## Final Subsequent Environmental Impact Report *for the* Pacific Gas And Electric Company Topock Compressor Station Final Groundwater Remediation Project

### Volume 1: Response to Comments

SCH# 2008051003

December 2017

Figure 2 Topock Project water supply wells, superimposed on illustration – from Kimley-Horn Final Drainage Report for Sacramento Wash Offsite Improvements (August 2016)

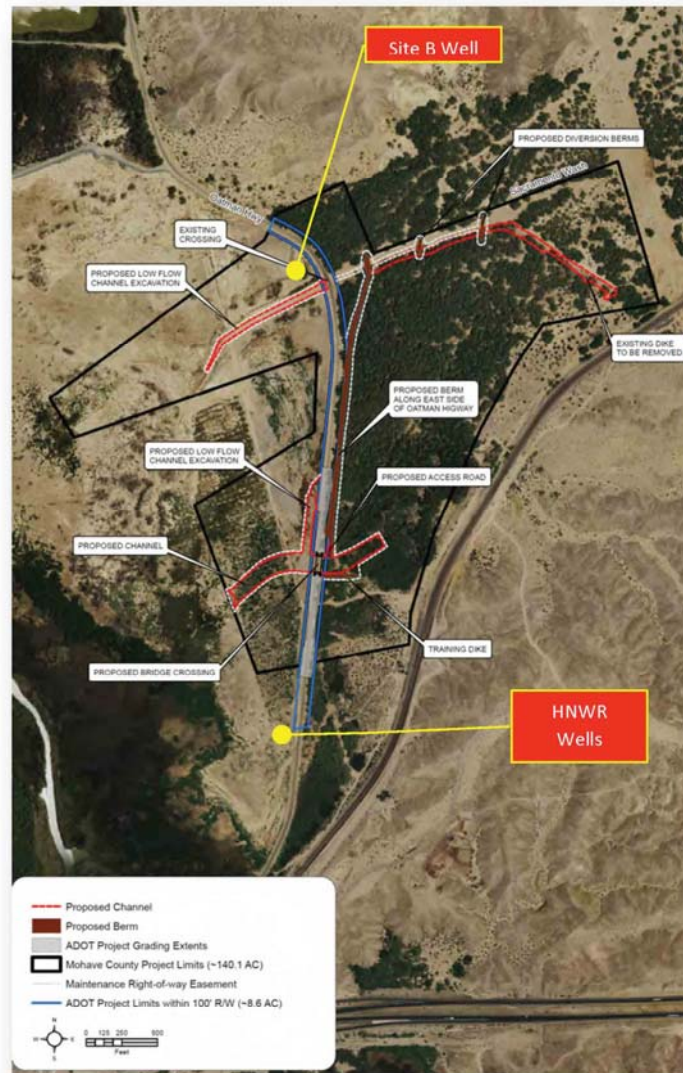
**Realistic Flood Impacts.** Second, flood magnitude estimates developed as part of the design have a bearing on the assessment of flood hazards or potential damage to Topock Project infrastructure, specifically the Site B and HNWR wells and related infrastructure, on the Arizona side of the Colorado River. See Figure 2, below. ADOT consultant Kimley-Horn used an existing 2D hydraulic model to simulate hydraulic response to a fairly small 2-yr, 30-minute storm event (see Figure 3, below). Relative to Topock Remediation System operation time-frame this is very short. To better assess the extent and magnitude of flooding, and associated erosion and deposition near critical freshwater source wells, Site B and HNWR wells, these simulations should consider a range of possible floods for example, ranging from the 25-yr storm event to the 100-yr storm event. These longer recurrence interval events are more realistic and well within the timeframe associated with PG&E design/operation of remediation system (i.e., 30 – 100 + years). The flow for the 100-yr 24-hr storm is estimated in the Oatman Highway drainage reports to be in the range of 50,000 to 90,000 cfs, depending on the method used, whereas the 2-yr 30-minute flow is only 3,200 cfs. (To get a sense for a 50,000 cfs flow, link here to a video of such a flow at Cow Swim, Desolation Canyon, Green River, Utah: [https://www.youtube.com/watch?v=s0MYj7I6\\_gw](https://www.youtube.com/watch?v=s0MYj7I6_gw).) Approximate inundation mapping (showing the lateral extent of flooding) for the area was developed by the Federal Emergency Response Agency (FEMA) as part of its Flood Insurance Rate Map (FIRM) development for the area – see Figure 4, below.

The reasonableness of the current design can be derived from examining Figure 2 of the Supporting Information of Attachment A in Comment T3, which shows the proposed ADOT and Mohave County Public Works Department project would construct channels to more efficiently route flood waters away from the Oatman Highway and toward the Colorado River. While the resolution of this figure is relatively poor, it shows the results from a non-regulatory 2D hydraulic model, and presents a 2-year 30-minute storm with an approximate depth of water between 0.1 to 1.1 feet for the HNWR-1 well site at the downstream end of the Sacramento Wash (approximately 1,200 feet downstream of the new ADOT bridge). The remedy infrastructure at HNWR-1A will thus be above the 2-year approximation elevation displayed in Figure 2. Therefore, while the area of the freshwater wells may occasionally be subjected to a flood, as indicated in Appendix IS of the SEIR, the impact would not result in new significant impacts or substantially increase the severity of significant impacts previously identified in the Groundwater FEIR. In the unlikely event of a flood event specifically at the freshwater wells, the wells would be too small to impede or redirect the flow of the flood and could easily be repaired in the unlikely event of surface damage to the wellhead.

Figure 2 Topock Project water supply wells, superimposed on illustration – from Kimley-Horn Final Drainage Report for Sacramento Wash Offsite Improvements (August 2016)

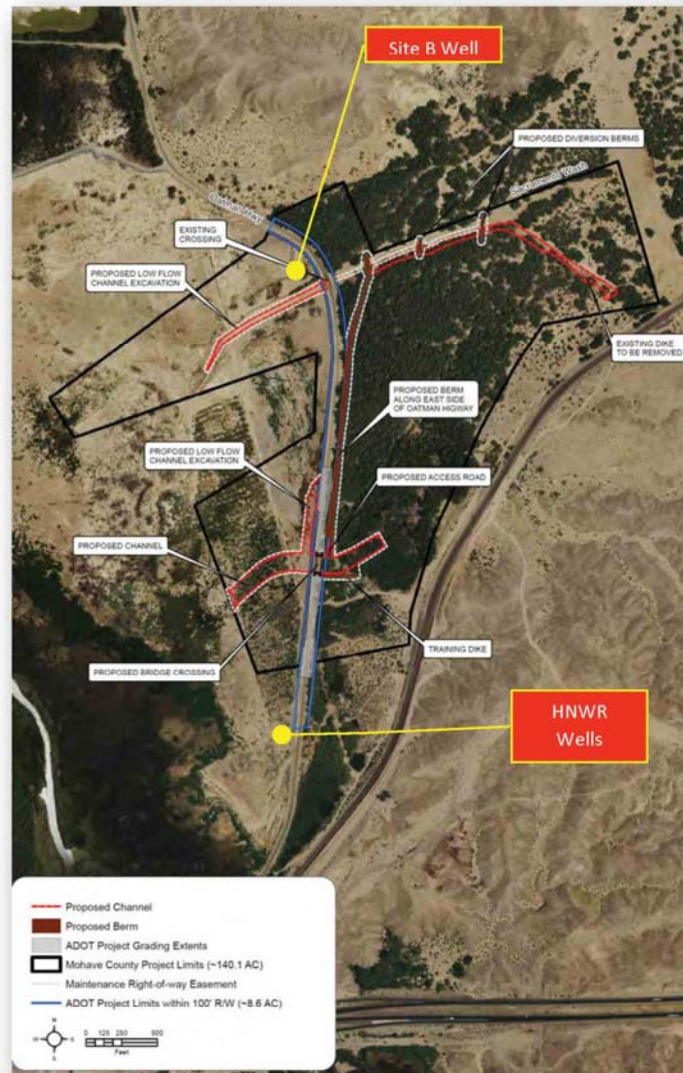
**Realistic Flood Impacts.** Second, flood magnitude estimates developed as part of the design have a bearing on the assessment of flood hazards or potential damage to Topock Project infrastructure, specifically the Site B and HNWR wells and related infrastructure, on the Arizona side of the Colorado River. See Figure 2, below. ADOT consultant Kimley-Horn used an existing 2D hydraulic model to simulate hydraulic response to a fairly small 2-yr, 30-minute storm event (see Figure 3, below). Relative to Topock Remediation System operation time-frame this is very short. To better assess the extent and magnitude of flooding, and associated erosion and deposition near critical freshwater source wells, Site B and HNWR wells, these simulations should consider a range of possible floods for example, ranging from the 25-yr storm event to the 100-yr storm event. These longer recurrence interval events are more realistic and well within the timeframe associated with PG&E design/operation of remediation system (i.e., 30 – 100 + years). The flow for the 100-yr 24-hr storm is estimated in the Oatman Highway drainage reports to be in the range of 50,000 to 90,000 cfs, depending on the method used, whereas the 2-yr 30-minute flow is only 3,200 cfs. (To get a sense for a 50,000 cfs flow, link here to a video of such a flow at Cow Swim, Desolation Canyon, Green River, Utah: [https://www.youtube.com/watch?v=s0MYj7I6\\_gw](https://www.youtube.com/watch?v=s0MYj7I6_gw).) Approximate inundation mapping (showing the lateral extent of flooding) for the area was developed by the Federal Emergency Response Agency (FEMA) as part of its Flood Insurance Rate Map (FIRM) development for the area – see Figure 4, below.

The reasonableness of the current design can be derived from examining Figure 2 of the Supporting Information of Attachment A in Comment T3, which shows the proposed ADOT and MCPWD project would construct channels to more efficiently route flood waters away from the Oatman Highway and toward the Colorado River. While the resolution of this figure is relatively poor, it shows the results from a non-regulatory 2D

hydraulic model, and presents a 2-year 30-minute storm with an approximate depth of water between 0.1 to 1.1 feet for the HNWR-1 well site at the downstream end of the Sacramento Wash (approximately 1,200 feet downstream of the new ADOT bridge). The remedy infrastructure at HNWR-1A will thus be above the 2-year approximation elevation displayed in Figure 2. Therefore, while the area of the freshwater wells may occasionally be subjected to a flood, as indicated in Appendix IS of the SEIR, the impact would not result in new significant impacts or substantially increase the severity of significant impacts previously identified in the Groundwater FEIR. In the unlikely event of a flood event specifically at the freshwater wells, the wells would be too small to impede or redirect the flow of the flood and could easily be repaired in the unlikely event of surface damage to the wellhead.
